Site SA29, Land south of St Stephen's Church, Horsted Keynes

AP11 Response by Helena Griffiths to 'Note to Inspector' by Sigma Planning on behalf of Rydon Homes

9th July 2021

Following examination of the Mid-Sussex Site Allocations Development Plan (DPD) - Matter 3, Day 5 – Thursday 10th June 2021

Figure A – density distribution of housing surrounding and including site SA29

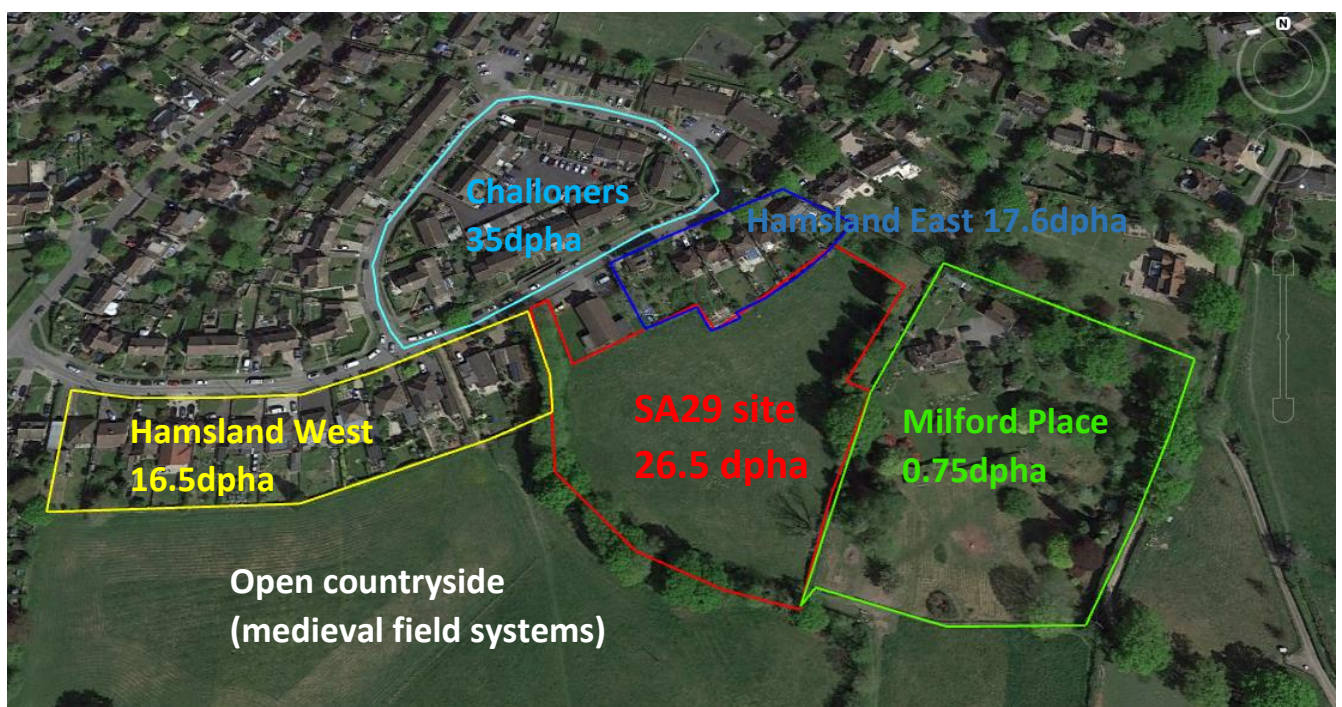
- The housing density in the central Challoners block is 35dpha (See Figure A - turquoise)
- The housing on the south side of Hamsland, currently overlooking the open countryside, and directly overlooking the proposed site of SA29 has a density of 17.6dpha (dark blue), and 16.5dpha to the west of the site (yellow).

- The density of the residential curtilage of ‘Milford Place’ on the eastern boundary of the site (green) is 0.75dpha (1 house on 1.33ha).
- The concern is not whether the density is achievable within the site, but is the density appropriate for a medieval field system with a high degree of intactness, in the HW AONB.

- To state that *'suitable landscape buffers'* exist is misleading, as inspection of the current layout in Figure B shows a minimal and inadequate buffer to the eastern boundary of the site, which should have space given over to the existing ecology, including foraging bats that use tree and hedge lines to navigate.
